Product Change Notice (PCN)

Subject: Datasheet Specification Change for the Intersil ISL8273M* Product

Publication Date: 6/28/2017

SIZE DETAILS FOR THE 16 EXPOSED PADS

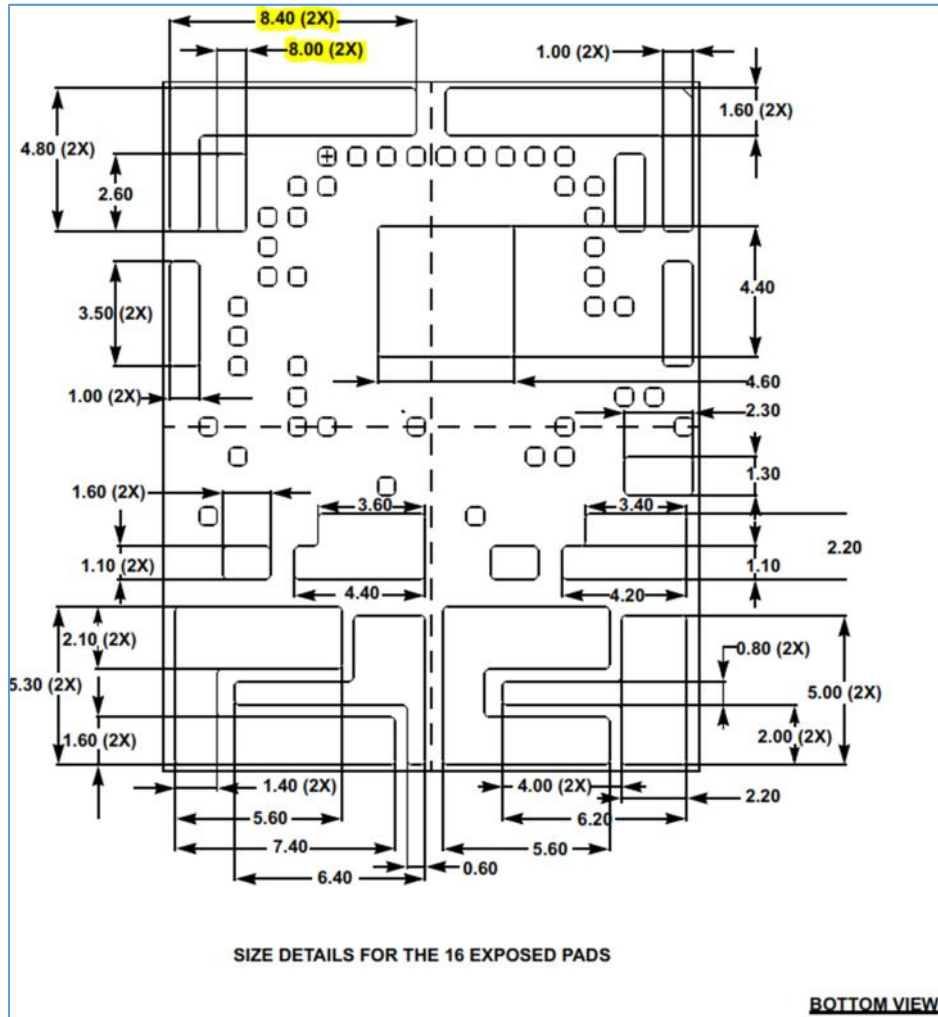
1. The RoHS EU exemption status on the datasheet.
2. Table 1. ISL8273M DESIGN GUIDE MATRIX AND OUTPUT VOLTAGE RESPONSE, where the ASCR Gain specification has changed from 140 to 100 db.
3. Correction to the POD (Package Outline Drawing) referenced in the datasheet. The updates to the POD correct the exposed pad dimension (bottom view). Below summarizes the dimension change : -

From :	To :
8.40mm (2x)	8.30mm (2x)
8.00mm (2x)	1.00mm (2x)
